GlaStar / Sportsman Service Bulletin 64- MANDATORY

Subject: Inspection of welded cage and seat assemblies for cracking.

Applicability: All Flying GlaStar/Sportsman Aircraft (Rev A. updated to include all Sportsman aircraft and 100 hour inspection for float plane operators.)

Figure 1. Cracking of weld at tube intersection.

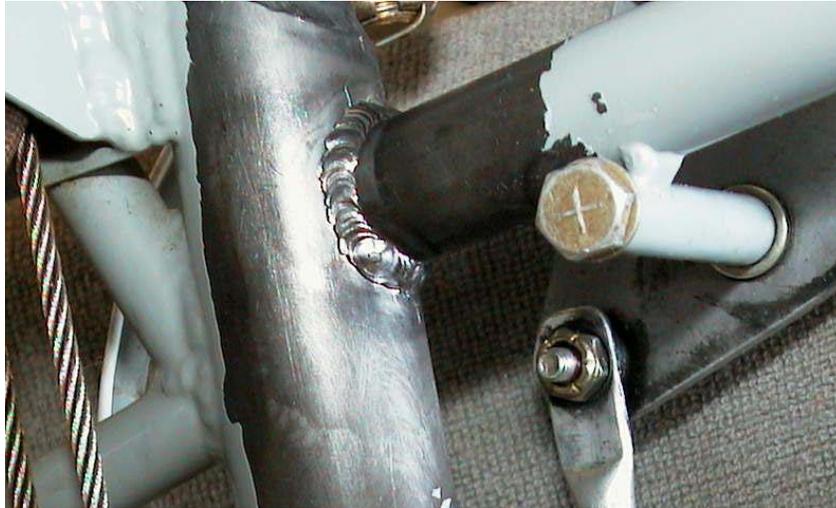
Item 1: We have recently been informed that, while performing an inspection of a GlaStar / Sportsman taildragger, cracking was noted on two welded tubes in the steel cage. Specifically, the affected tubes are the ones where the lower 3/4" diameter tube on the truss above the doors intersects with the 1" diameter tube on the vertical truss just aft of the main door. The vertical tube has a 1-1/8" sleeve welded over it at this intersection. The cracking was evident on both sides of the aircraft, limited to the forward side of the 1-1/8" sleeve. The crack was visible through the powder-coat finish. Reference Figure 1.

Based upon inspection of this weld from the photo and our conversations with the repair facility, it appears to us that the welds are separating from the tubes right at the weld line. Often, fatigue cracking of tubular structure, will occur in the heat affected zone and the cracking will occur slightly away from the weld bead itself. The failure of the weld right at the weld bead (as in this case) is usually evidence of a cold weld.

Based upon our review of the photo and information gathered, we believe that the weld in question is that of a MIG process. In general, the MIG weld will be rougher and will tend to have a convex weld bead, whereas the TIG weld will be smoother and generally have concave weld beads. When done properly, MIG and TIG are equally sufficient welds. However, operators performing MIG welds must be extra careful not to cold weld or cold lap a joint.

Figure 2. Points of inspection on fuselage cage structure.

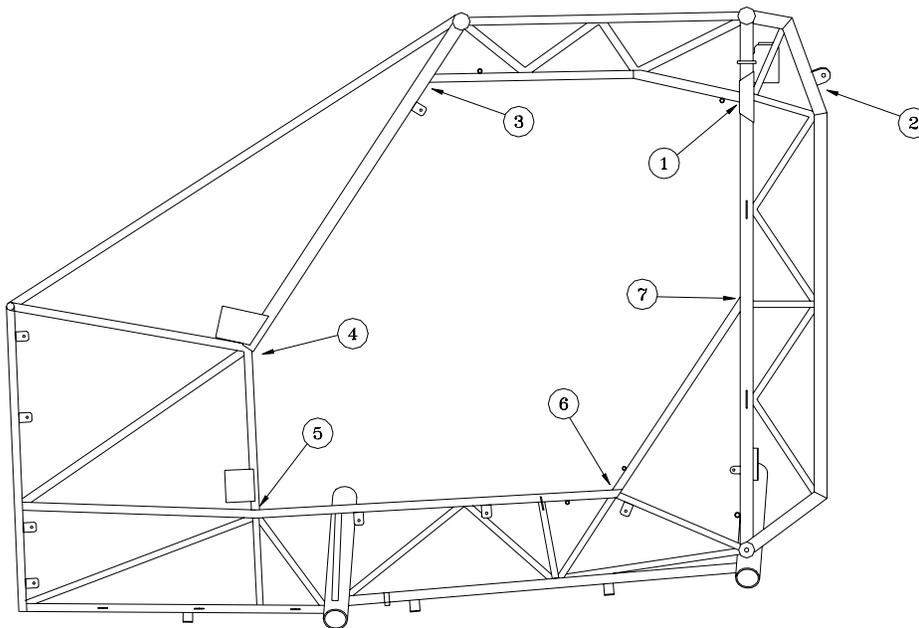
Although cracking was only discovered at point 1 in Figure 2, it is recommended that you inspect the other points as well. These points make up the structural ring of the door, which must transfer the shear loads and bending moment through the fuselage.

Item 1: Before next flight, the owner shall perform a visual inspection of the tubes and welds indicated in Figure 2 below. Although the GlaStar / Sportsman cage is a highly redundant tubular structure, these specific joints are identified as critical to inspect for the purposes of this service bulletin.

Visual inspection should be done with a mirror and flashlight. You will need to remove any interior covers that might be installed which impede complete access to the desired joints. Carefully look for any signs of cracking in the vicinity of the weld bead or right under the weld bead. The powder coating used on the cages and other structure is brittle enough, that should any cracking occur or be severe enough under the coating, the crack will transfer through to the surface and be visible to the eye. You may want to pick at or press the powder coat with the edge of a wooden tongue depressor to see if the coating has bridged any initial crack.

After you have complied with the visual inspection described herein, it is recommend that you fully inspect the points identified in Figures 2 and 3 above at your next and all subsequent annual inspections. Additionally it is recommended that you inspect the following areas on a routine (annual) basis:

Figure 3. Seat base where cracks have occurred.

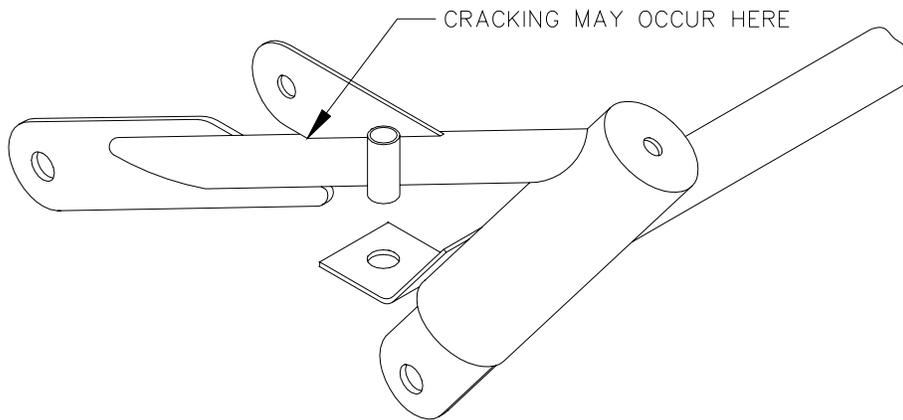
Item 2: We have also been informed, that cracking of a seat base tube has been discovered on more than one occasion where the owner (or 3rd party build centers) have modified the seat back to a "high back" configuration. To date, we are unaware of any cracking of the "stock" seat base tubes; thus, it is possible that extending the height of the seat back has overstressed the seat base from that originally designed. Note: The specific part number of the "stock" base is the 802-03000-03. This part (currently in production) is known as the "second run" seat base in the assembly manuals and can be seen in Figure 28, page 68 of the Section X Final Assembly. Cracks were discovered where the seat back pivot tab is welded to the tube as can be seen in Figure 3.

Item 2: The seat base should also be inspected for signs of cracking. Builders who have modified their seat backs to the “high back” configuration should pay particular attention to the area noted in the figure above.

If you feel you have identified an area in item 1 or 2 above that is showing signs of cracking, it is recommended that you inspect the area further with a penetrant inspection. These kits are available through most aircraft supply companies. Penetrant inspection works by having a dye penetrate into a flaw such as a crack and then after the application of a developer, the highly visible dye shows up on the contrasting surface of the developer. It is a very cost effective way to inspect for weld integrity or on older aircraft for fatigue cracks.
